INDIANA DEPARTMENT OF TRANSPORTATION

APPROVED MINUTES

August 18, 2016 Standards Committee Meeting

RE: Minutes from the August 18, 2016 Standards Committee Meeting

805-SGCO-06 CONTROLLER CABINET TYPE G ON PEDESTAL (WITH MARKUPS)

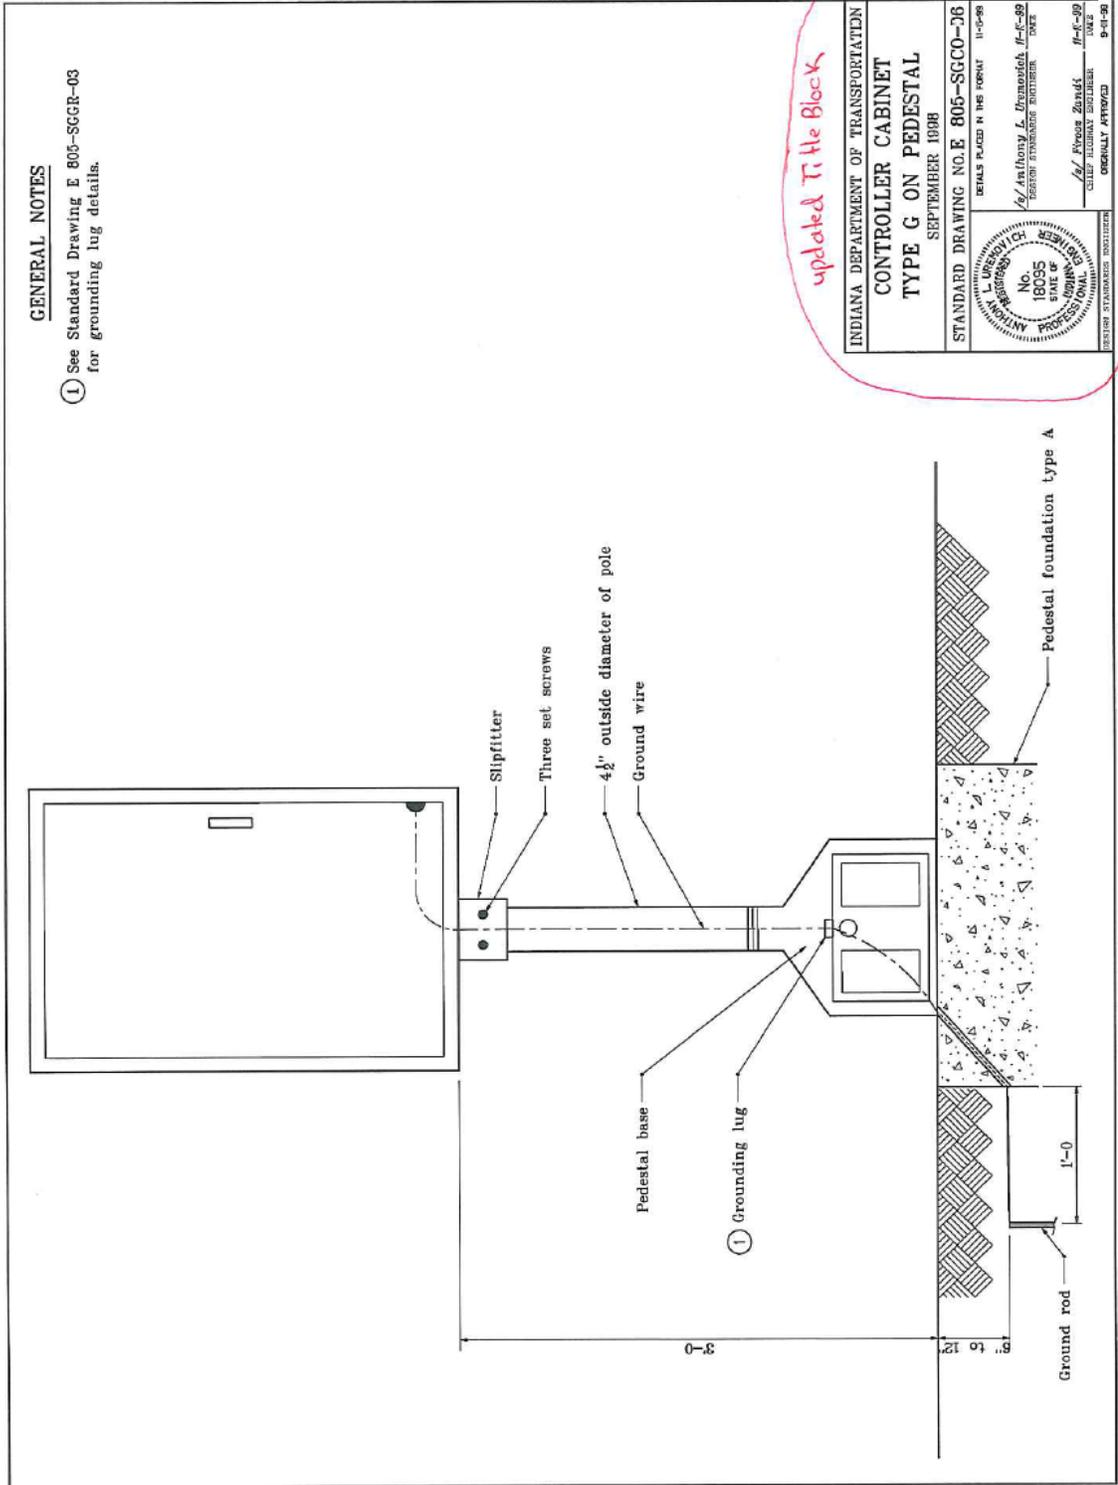
General 1) updated Text Font
 2) updated Drawing Scale

updated Title Block

805-PPBA-02 TYPICAL PEDESTRIAN PUSHBUTTON ASSEMBLY LOCATIONS (DRAFT)

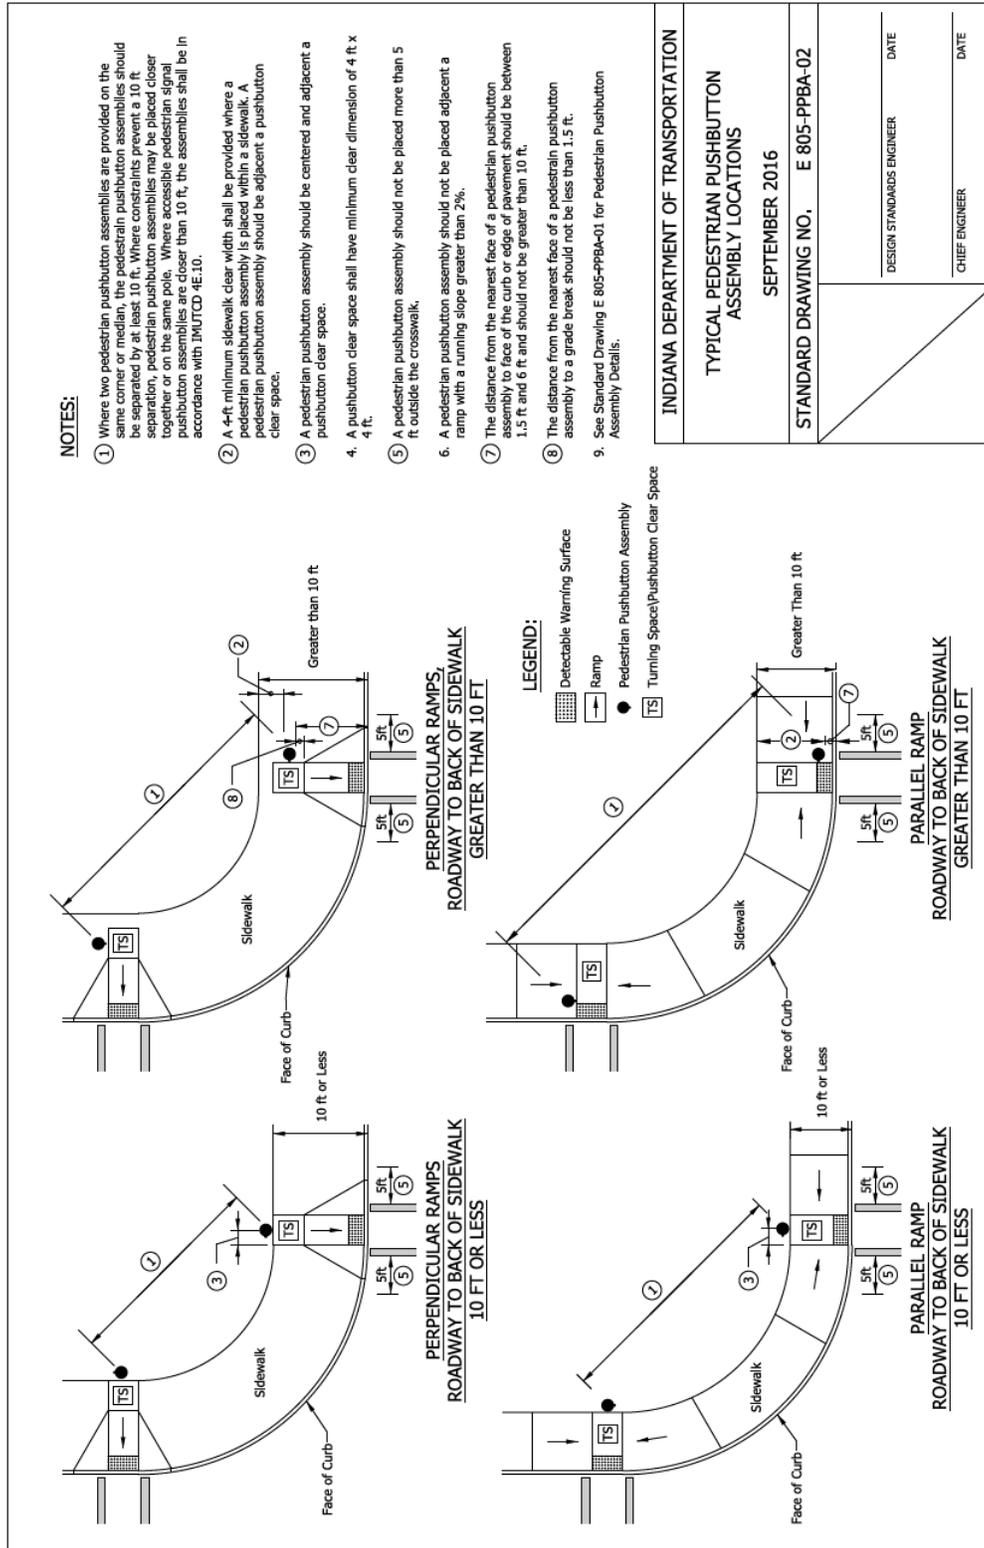
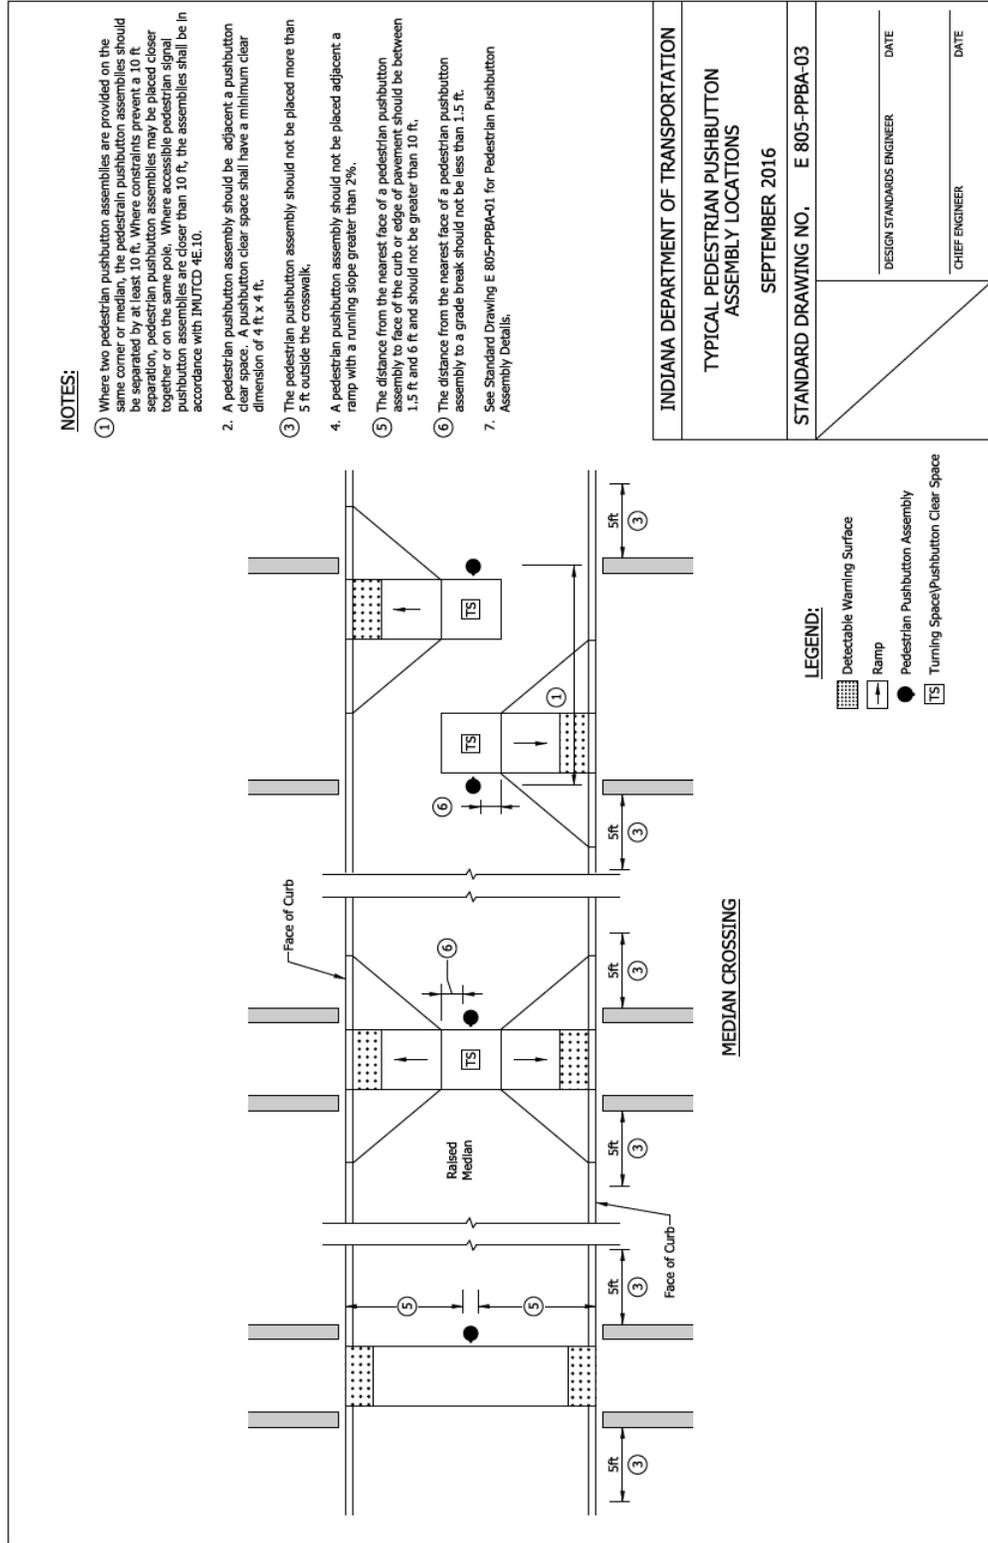
Mr. Bruno asked if the drawings could reflect the correct configuration for the pedestrian signals, since what is currently shown is the old configuration. Ms. Phillips agreed and said that it will be addressed and updated.

Much discussion ensued concerning making sure the ped heads (pedestrian push button assemblies with arrows) are pointed in the correct directions and that they are located properly no matter what the site conditions make dictate. Ms. Phillips expressed that the intention is to bring forward the desired intentions of the MUTCD. Mr. Pankow expressed concern about the language used for the designers to make sure the MUTCD is followed, and Mr. Cales expressed that there should be a detail shown on the plans for special circumstances due to possible retrofit of existing conditions. Ms. Phillips also expressed the desire to maintain accessibility of the devices. Ms. Phillips agreed that some editorial revisions are necessary for clarification. (Surface requirements, illustration of ped heads, language clarification, order of min. max., arrow direction requirements.)

REVISION TO IDM FIGURE 51-1P PUSHBUTTON CLEAR SPACE

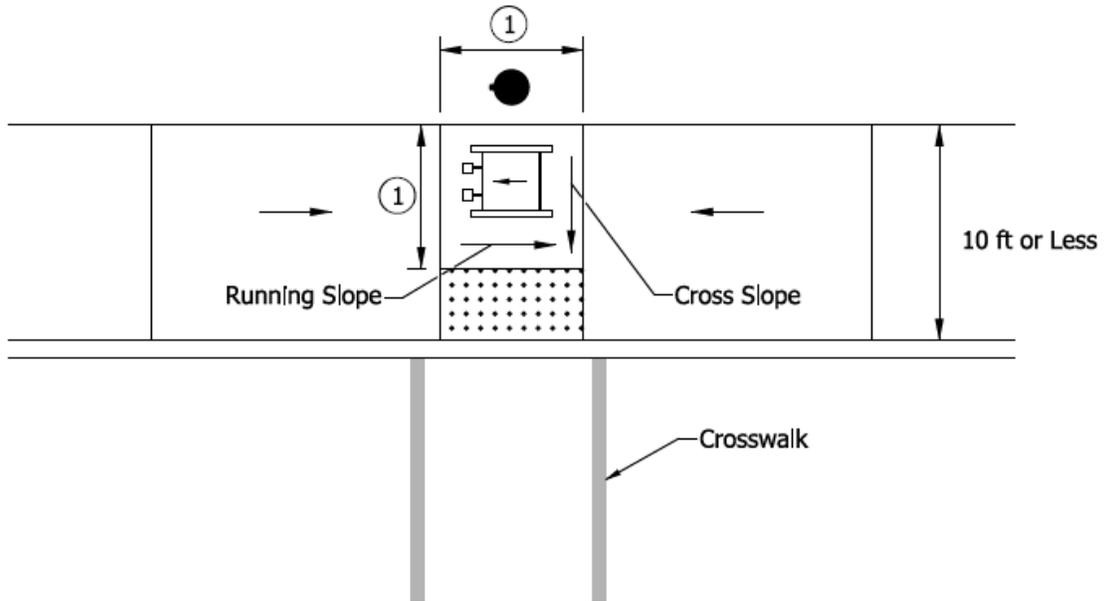
The running slope and cross slope of a clear space are based on the orientation of the pushbutton assembly. See Figure 51-1P, Pushbutton Clear Space. The running slope may be consistent with the grade of the sidewalk. The cross slope must be 2.00% maximum.

REVISION TO IDM FIGURE 51-1Q PEDESTRIAN PUSHBUTTON ASSEMBLY OUTSIDE THE BACK EDGE OF SIDEWALK, PREFERRED

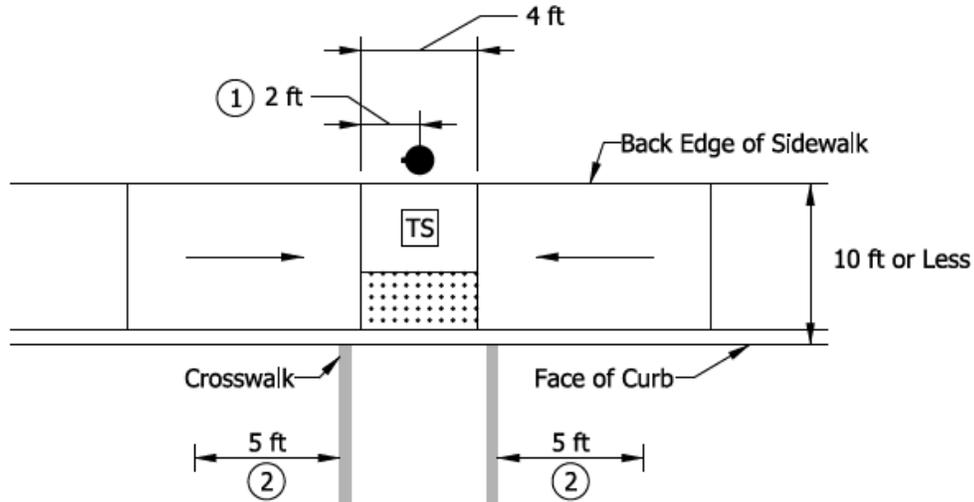
- a. Pedestrian Pushbutton Assembly Outside the Back Edge of Sidewalk. A pedestrian pushbutton assembly should not be placed more than 5 ft outside the associate crosswalk. A pushbutton assembly should be centered adjacent a pushbutton clear space. See Figure 51-1Q, Pedestrian Pushbutton Assembly Outside the Back Edge of Sidewalk, Preferred.

REVISION TO IDM FIGURE 51-1R PEDESTRIAN PUSHBUTTON ASSEMBLY WITH A SIDEWALK OR BUFFER

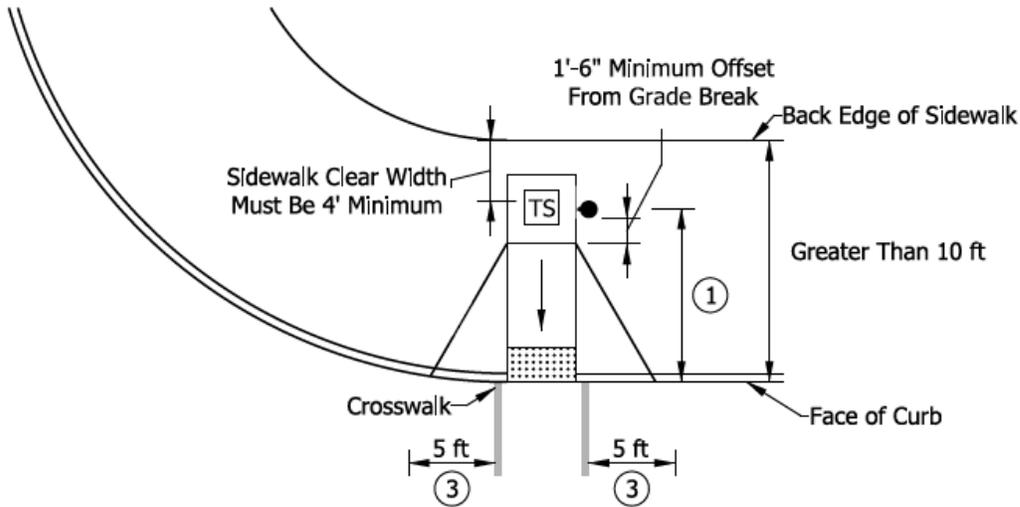
See Figure 51-1R, Pedestrian Pushbutton Assembly Within a Sidewalk or Buffer.

3. Grade Break. Where a grade break is adjacent a pushbutton clear space it is preferred to offset the pedestrian pushbutton assembly a minimum of 1.5 ft from the grade break. A wheelchair user positioned on a grade break may become unstable while actuating the pushbutton assembly and enter into traffic prematurely. Figure 51-1R, Pedestrian Pushbutton Assembly Within a Sidewalk or Buffer.

REVISION TO IDM FIGURE 51-1S PEDESTRIAN PUSHBUTTON MOUNTING HEIGHT AND SIDE REACH

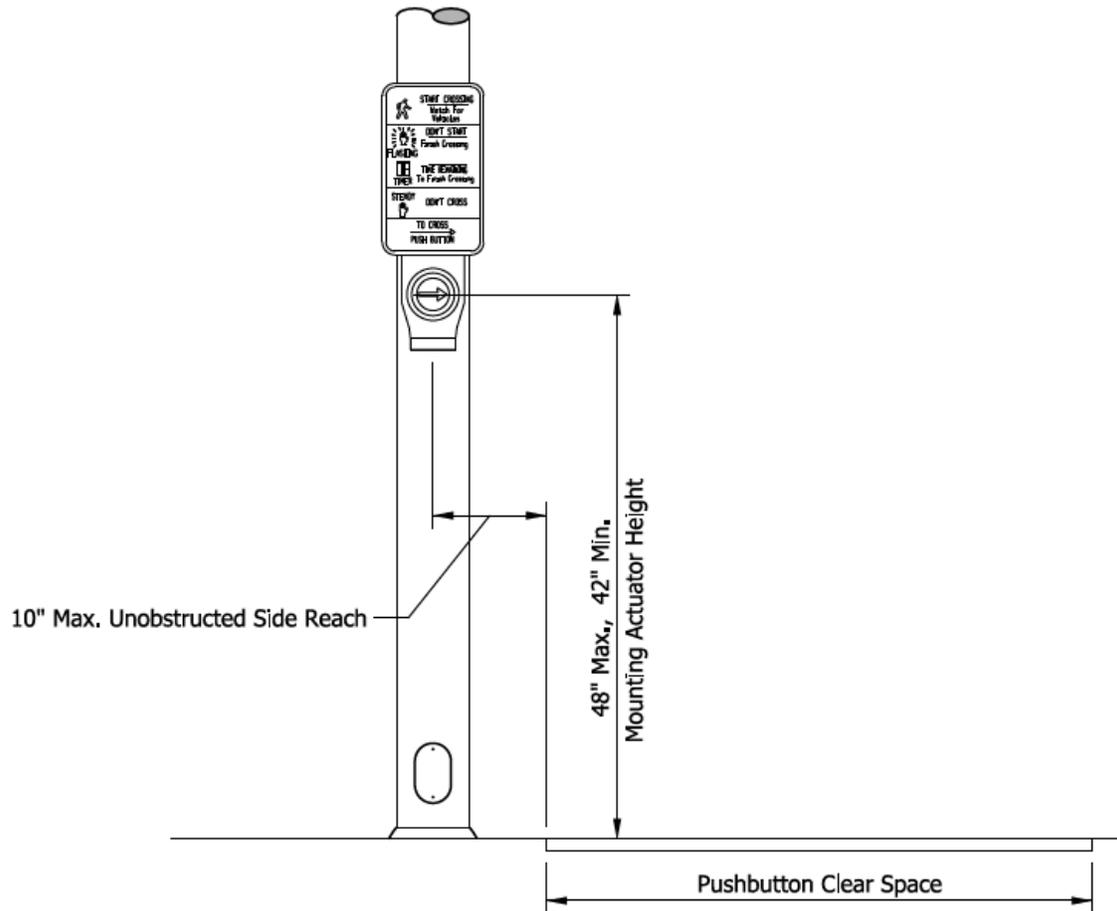
5. Mounting Height and Side Reach. [R406] The actuator of the pedestrian pushbutton assembly must be located between 42 in. and 48 in. above the pushbutton clear space and within a 10-in. unobstructed side reach. See Figure 51-1S, Pedestrian Pushbutton Assembly Mounting Height and Side Reach. Where pole placement is limited, a 6 in. or 12 in. pushbutton assembly extension may be used to meet the side reach criteria.

REVISION TO IDM FIGURE 51-1T ORIENTATION OF PEDESTRIAN PUSHBUTTON ASSEMBLY

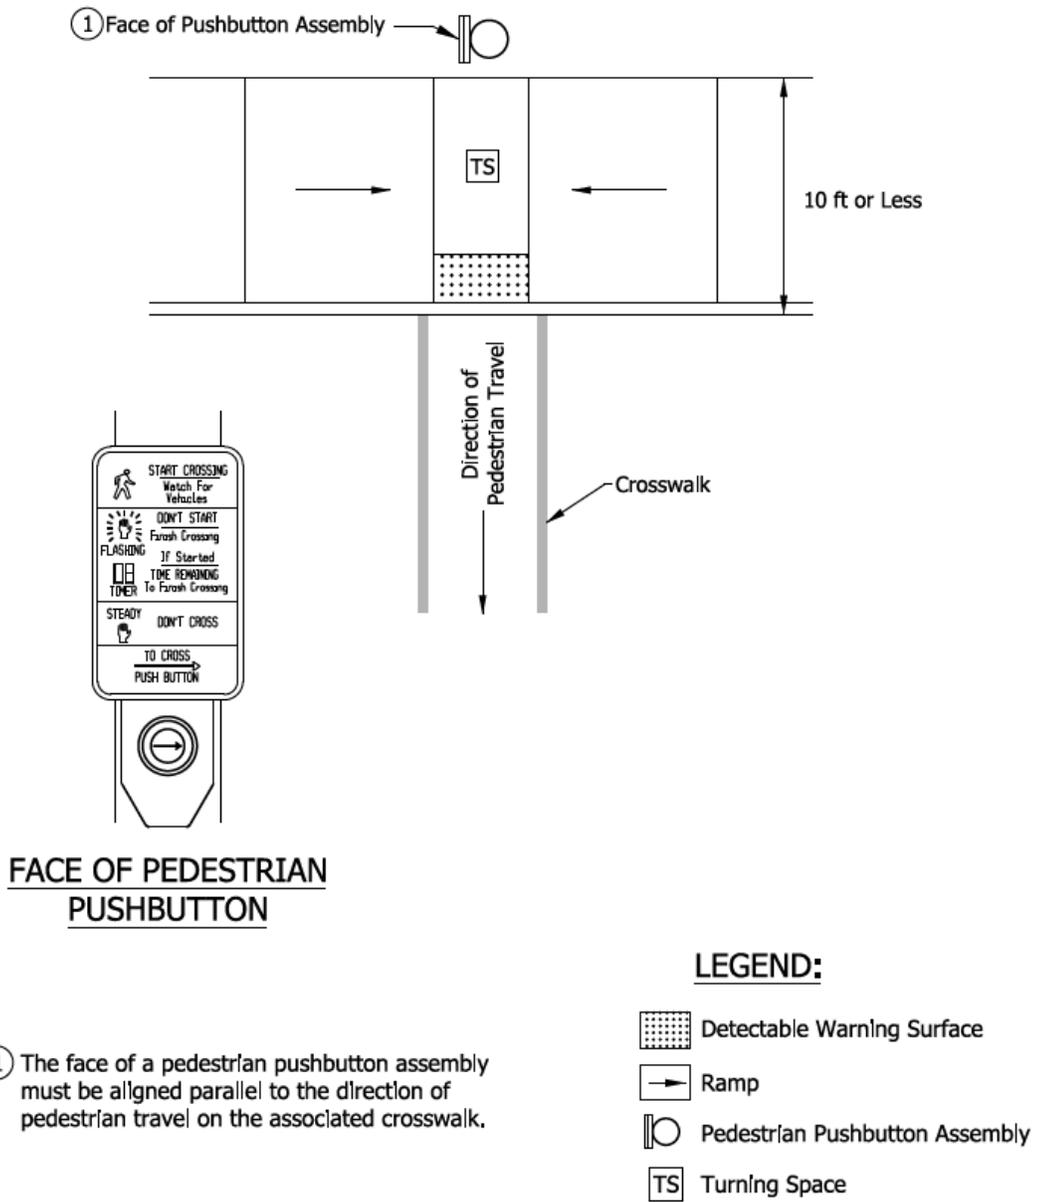
6. Orientation. The face of a pedestrian pushbutton assembly must be aligned parallel to the direction of pedestrian travel on the associated crosswalk. See Figure 51-1T, Orientation of Pedestrian Pushbutton Assembly.
